SVE BULLETIN

QVM Bulletin: Q-285 Date: 21, February 2018

2018 Super Duty Aftermarket CHSML Access

Models Affected: 2018 Model Year Super Duty Pickups and Chassis Cabs

Figures 1: CHMSL feed location at end of frame

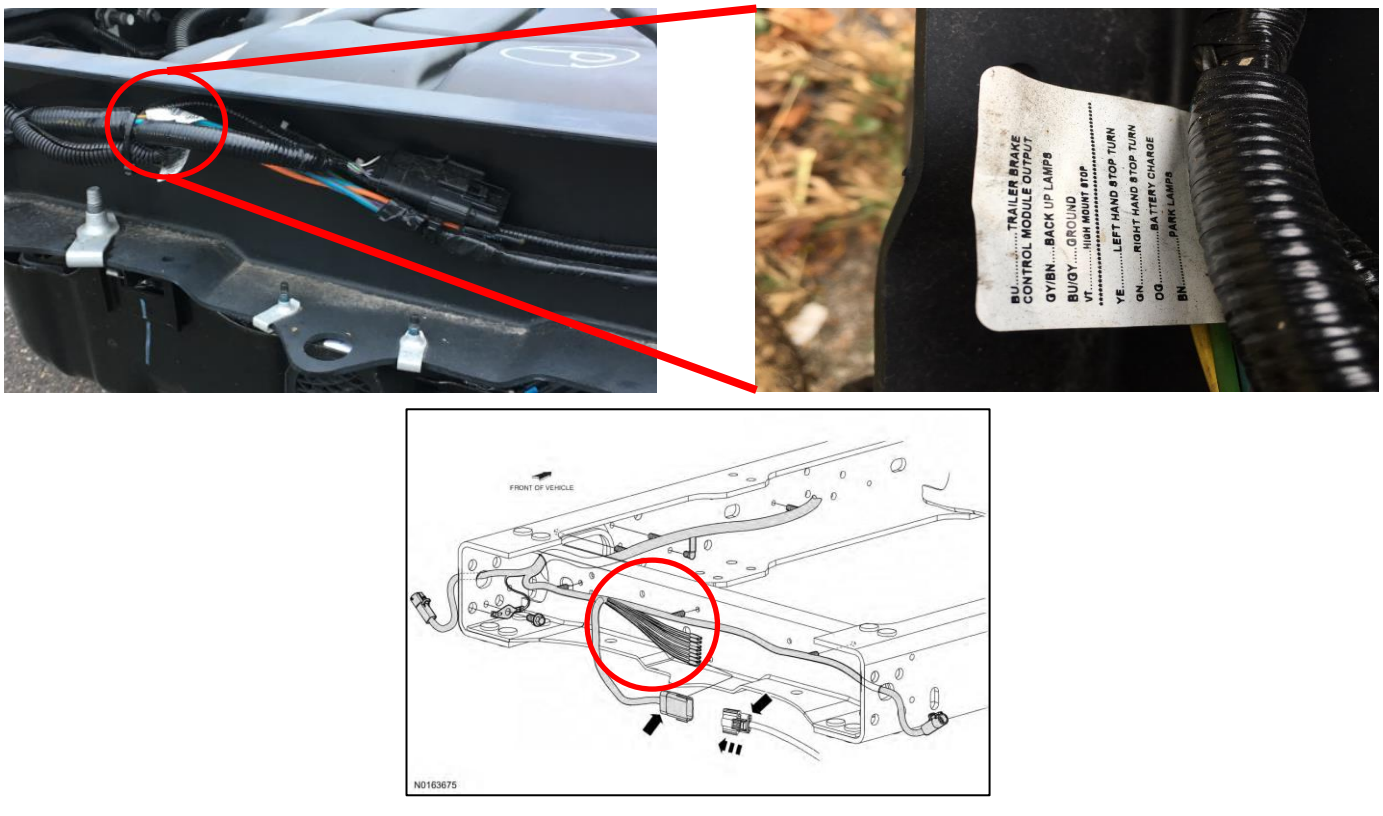
Description: Starting 2018 Model Year, a CHMSL feed is provided at the end of frame for all Super Duty vehicles (see figure 1). This is a 5 amp fuse protected feed.

Wire Color	Circuit No.	Circuit Intent	Description
Violet	CBP04	Service Brake signal output	**6.7L Diesel, 6.2L / 6.8L Gas – BCM Pin C2280G-7**
			Intended for upfitter added CHMSL. BCM fuse F4, 5 Amp – Blunt cut taped to harness at rear of frame on left hand side
